NCC (BCA) & Access Assessment
SSDA Stage

TWEED VALLEY HOSPITAL

Revision 3

Date: 19 September 2019

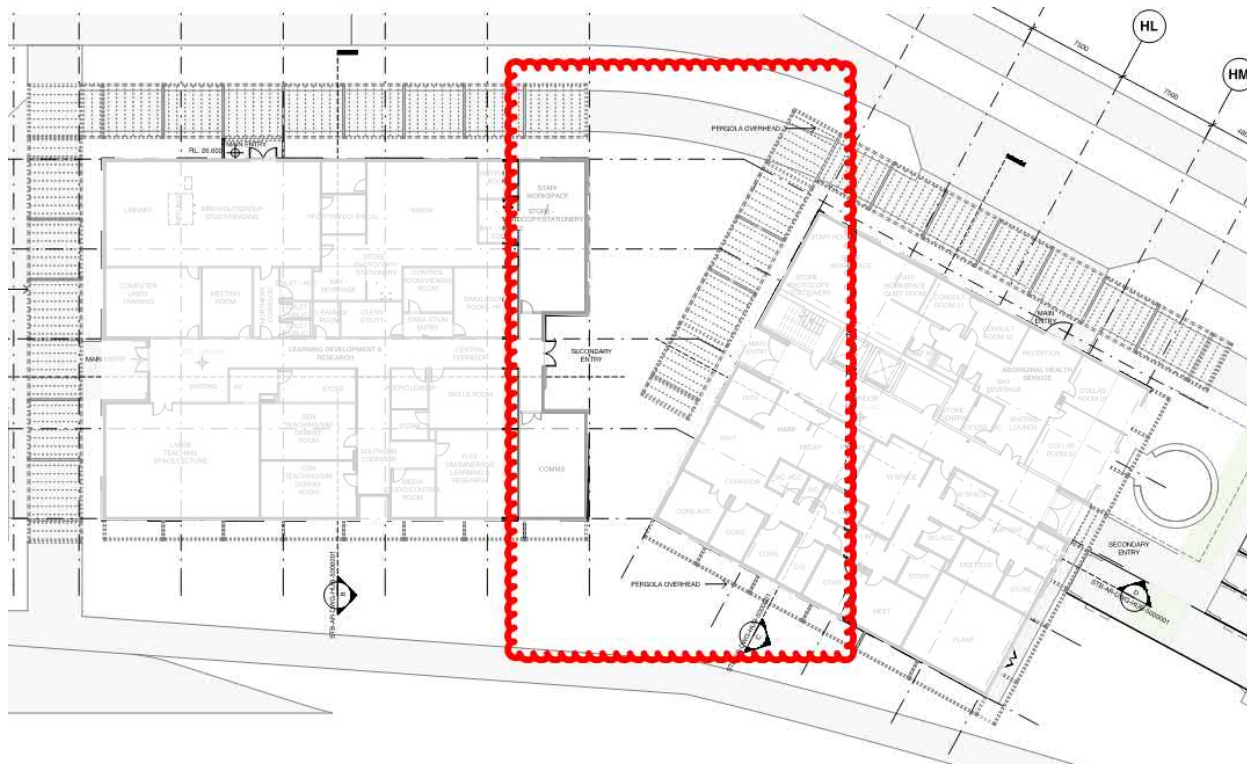
Confirmation is required with respect of the proposed use and whether it will constitute a 9b classification. The current plans show encroachments on the required 18m setback where the external walls are proposed to be loadbearing to the two storey part. As such, structural engineer will need to verify compliance with Spec C1.1 accordingly. Area of concern is as shown below.

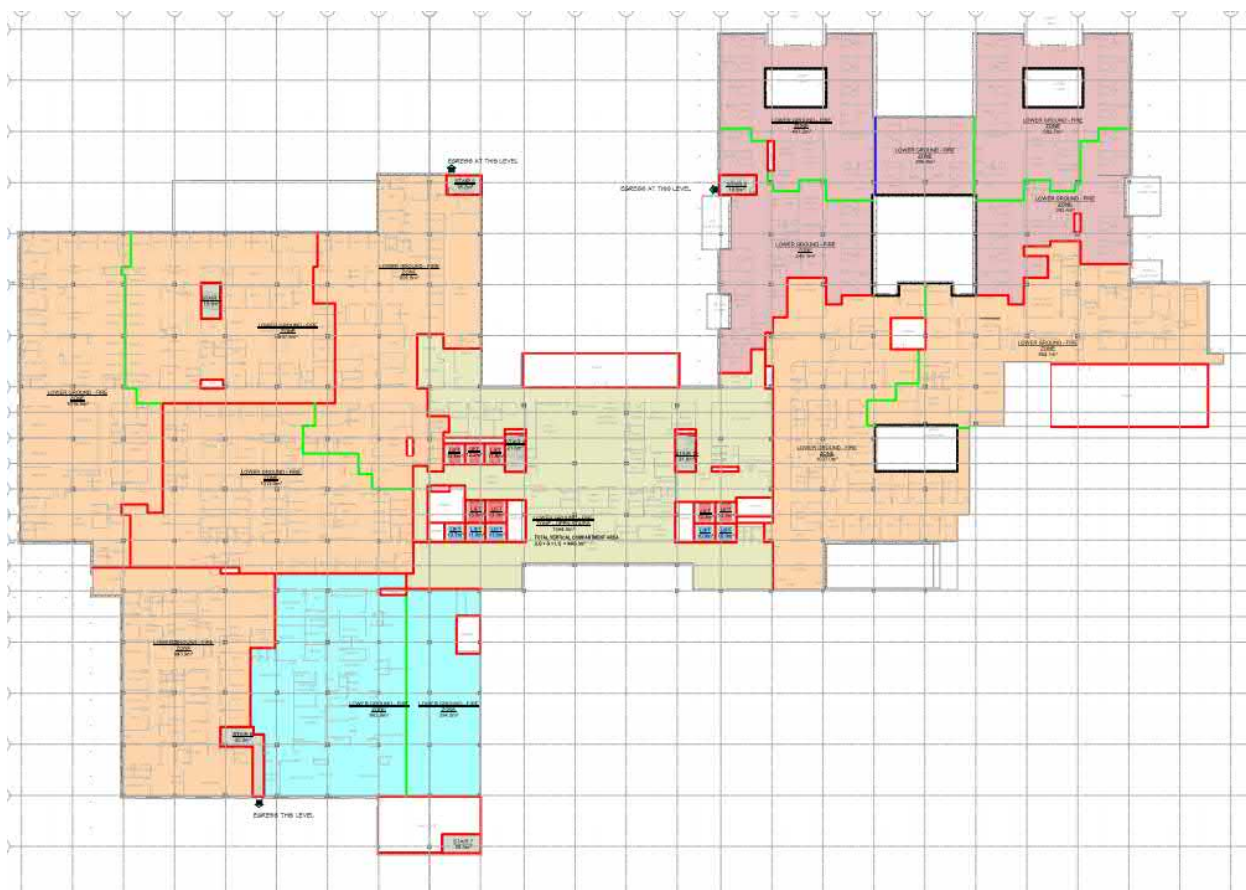
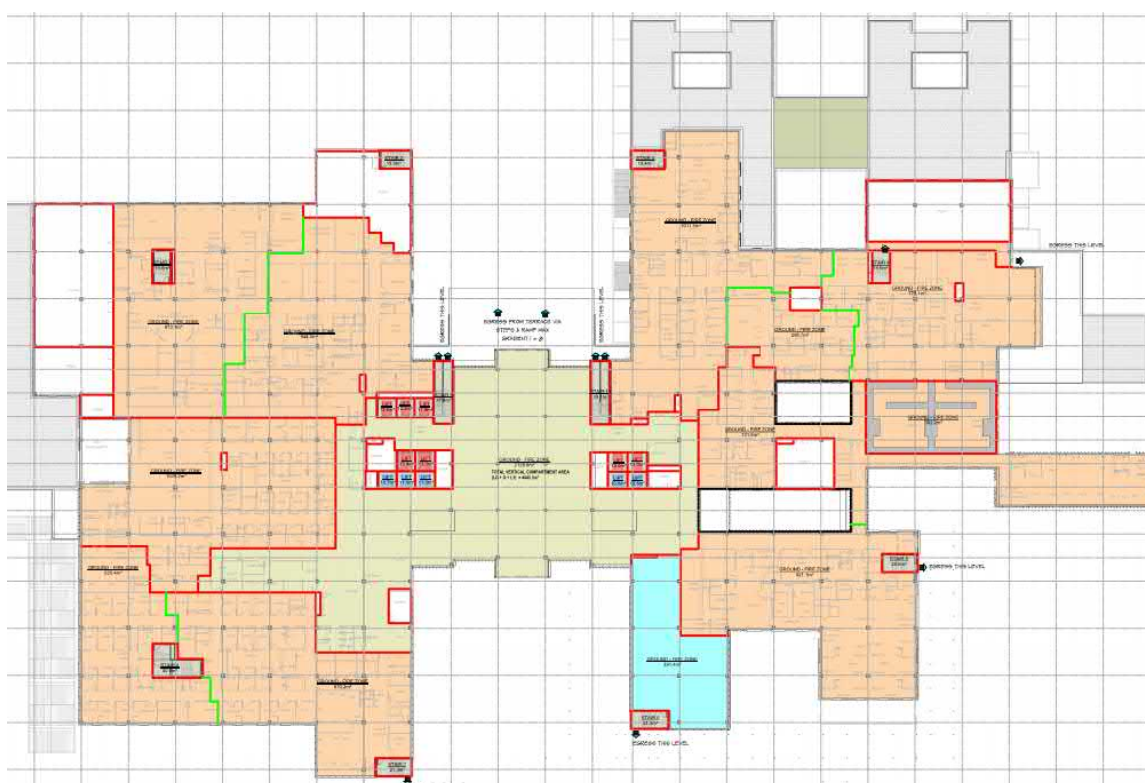
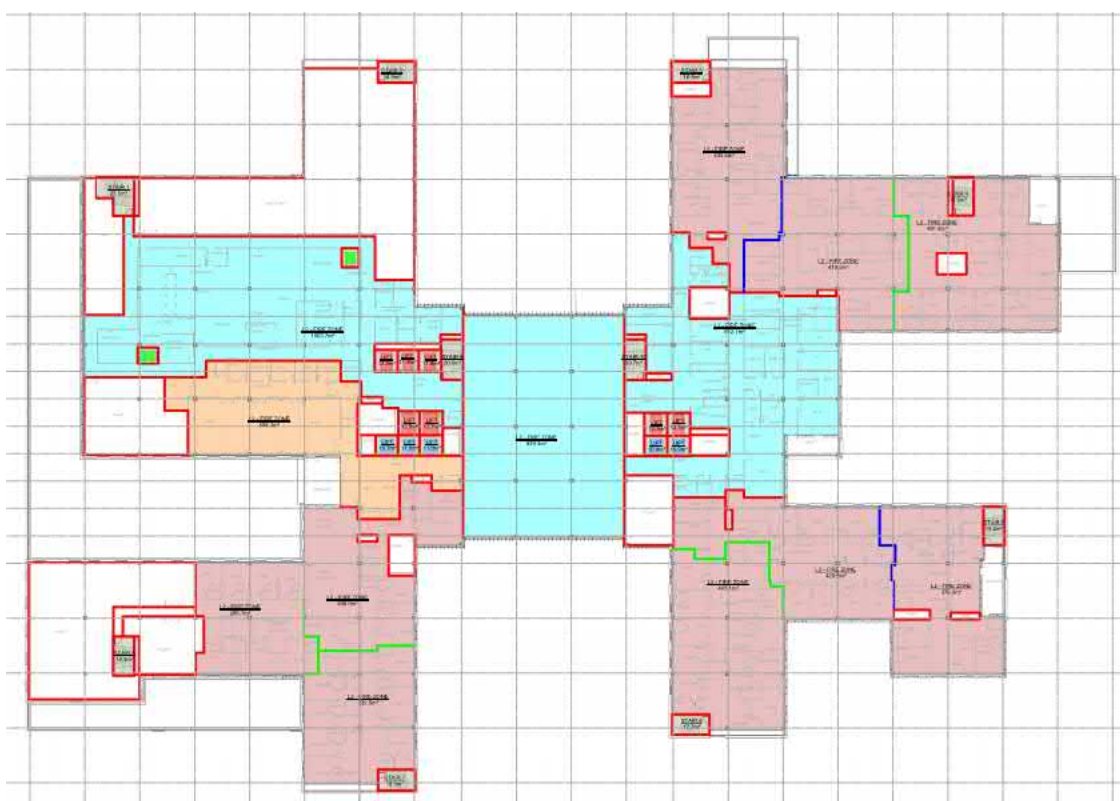
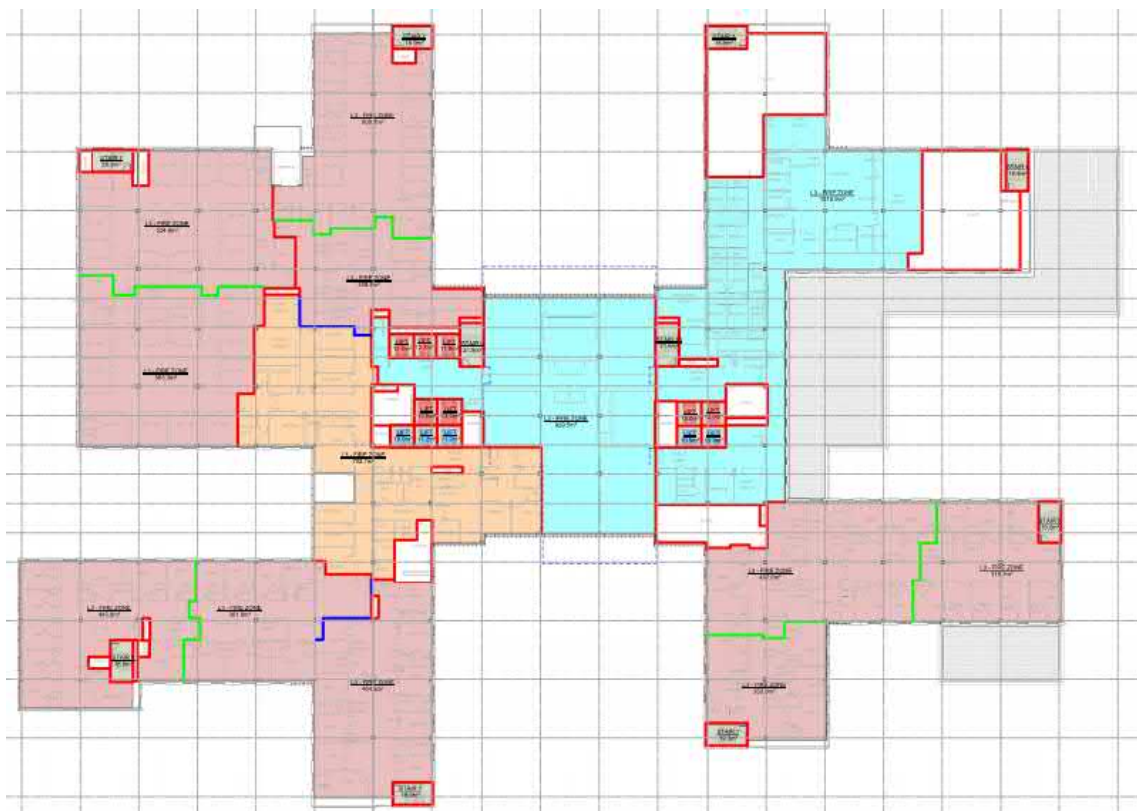
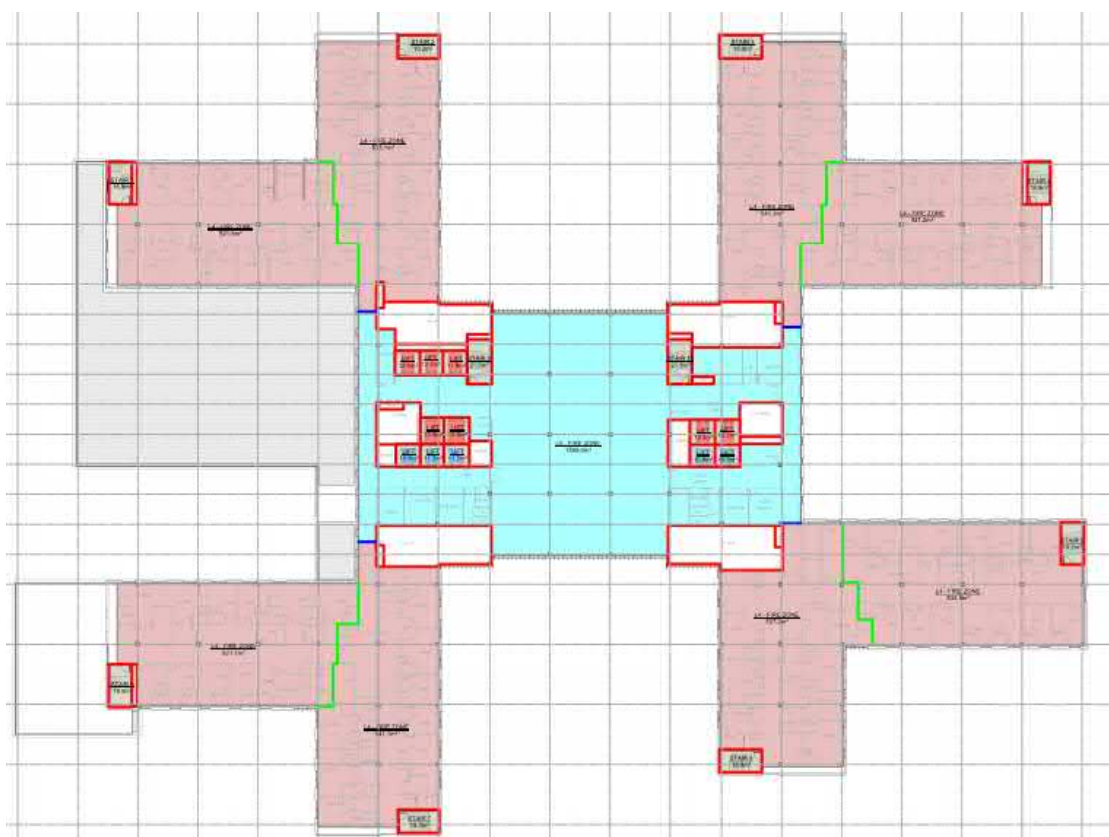
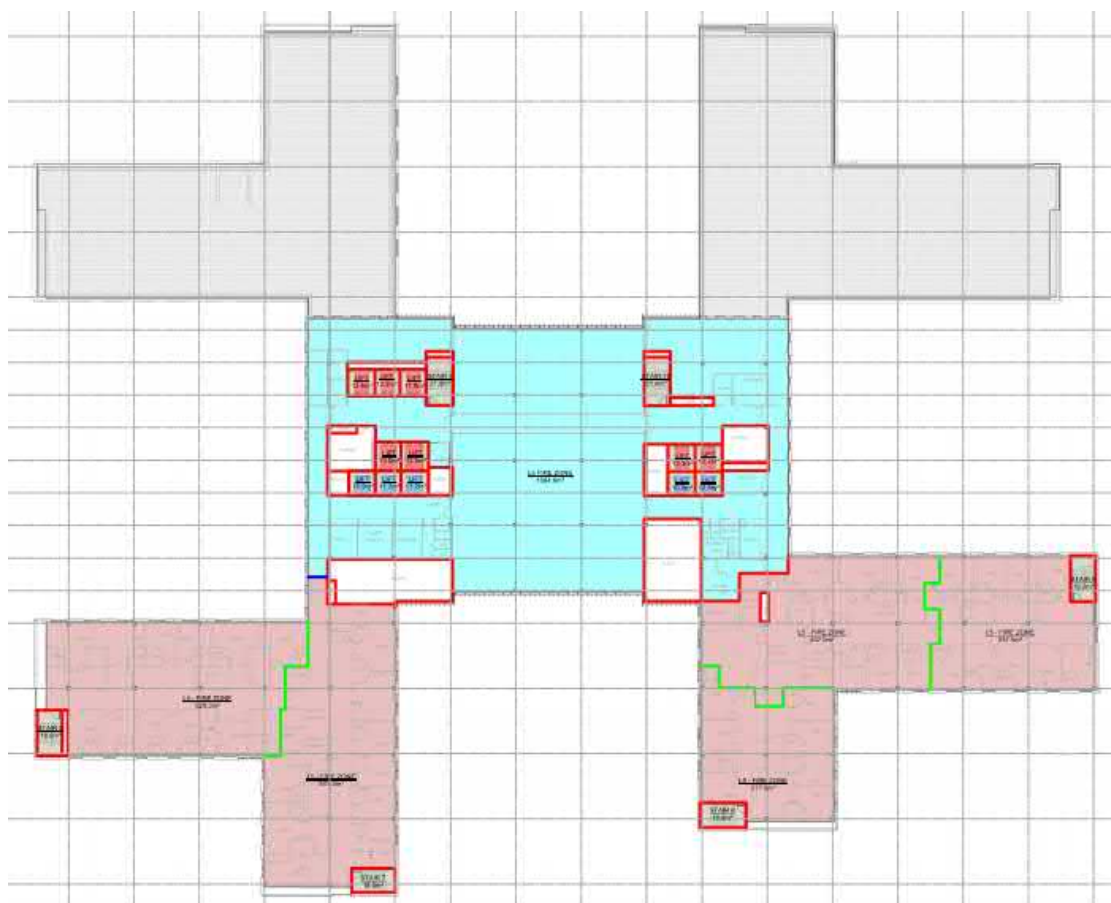
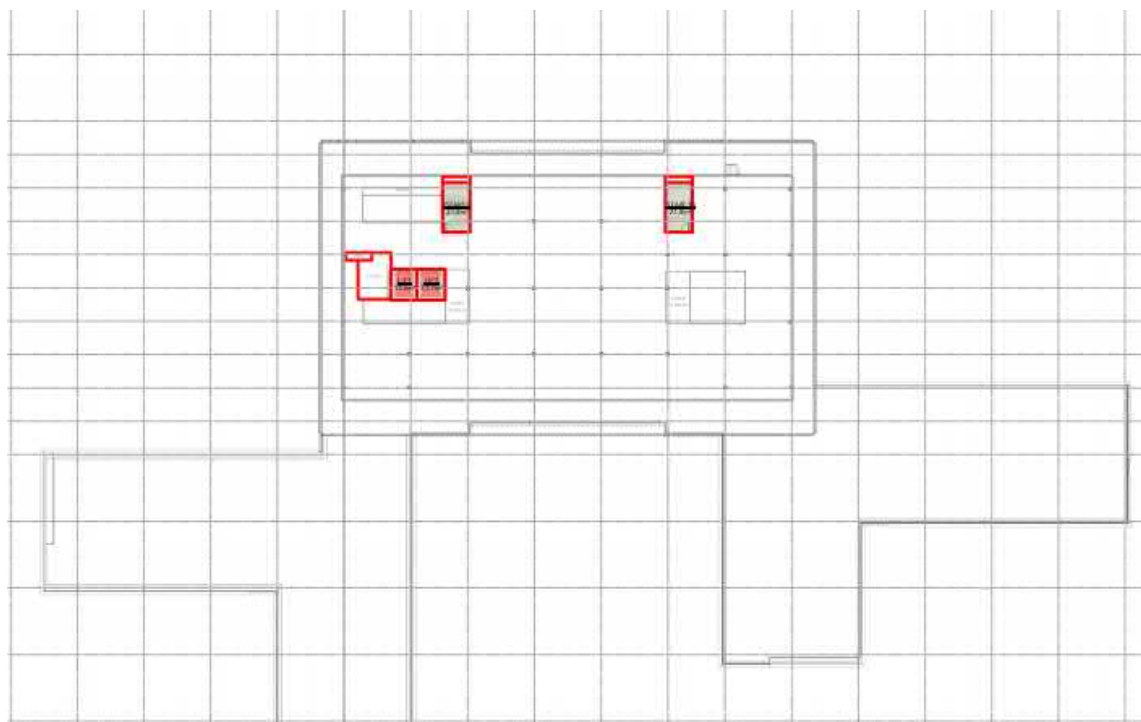
Compartmentation plan will need to be updated wherever services noted under this clause are proposed.

Updated compartmentation plan will need to be provided to BM+G for review and comment.

Figure 2 –Extract from Overall Lower Ground Floor Plan

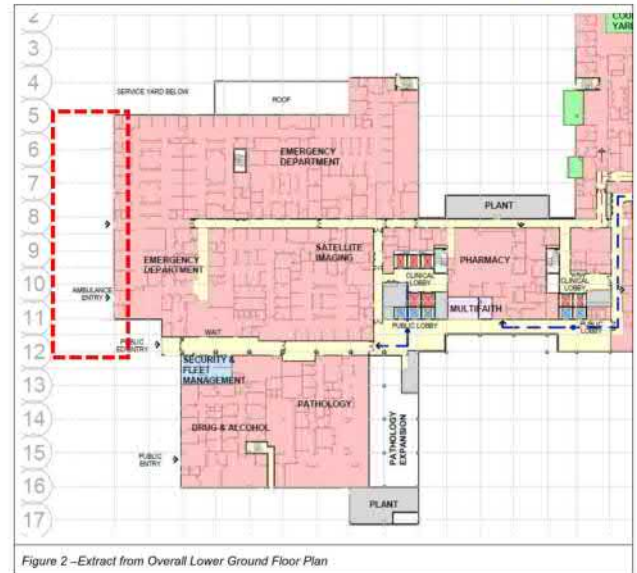
If a kerb is provided, separating the drop-off area from the pavement, a compliant kerb ramp will need to be provided. The detailing of the parallel set-down zone will need to satisfy the provisions of AS2890.6:2009.

If the set down is flush with the pavement, tactile indicators and bollards are required to be provided as per Figure 2.5B of AS1428.4.1:2009:
